**SUBJECT:** Potential decreased service life of Slick 4-cylinder magneto distributor gear assemblies. **Based on process and component improvements following the initial release of this service bulletin, the serial number range is being extended in this revision. Magnetos previously returned for compliance to SB1-15 must be returned or inspected for compliance to this revision SB1-15A.**

**AFFECTED:** The following 4-cylinder magnetos with serial numbers between **08090001 thru 16071072**, K3822 distributor block replacement kits, and K3008 distributor gear assemblies dated **September 26, 2008 thru September 1, 2016:**

Figure 5. K3008 Distributor Gear With Monel Electrode

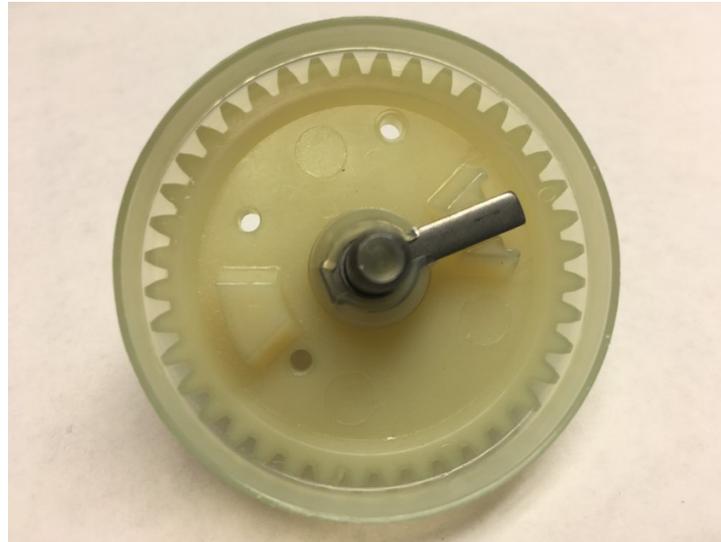
**If it is not possible to confirm the version of the distributor gear that is installed in a given magneto from maintenance records, the magneto may be removed from the engine in order to have the housing and distributor block removed to allow visual inspection of the distributor gear. Distributor gears with Copper electrodes must be replaced with distributor gears with Monel electrodes.**

While the subject magneto distributor gear assemblies met all acceptance criteria at the time of production, the previous Service Bulletin was issued in order to eliminate any affected 4-cylinder magneto distributor gear assemblies (see below: MAINTENANCE PARTS AFFECTED). Champion Aerospace improved the new replacement K3008 distributor gear assembly to address this issue. Champion Aerospace has made further improvements to the K3008 distributor gear assembly with the final change being the change from a Copper to a Monel distributor gear electrode as of August 2016, making the ultimate product more robust.

**COMPLIANCE:** REMOVE affected distributor gear assembly in subject magnetos and REPLACE with replacement distributor gear assembly, K3008, as soon as possible, not to exceed the next 50 hours. Document Service Bulletin compliance as written entry in applicable Aircraft and/or Engine logbook.

REMOVE K3008 distributor gear assembly in subject magnetos and REPLACE with replacement K3008 distributor gear assembly **as soon as possible**, not to exceed the next 50 hours.
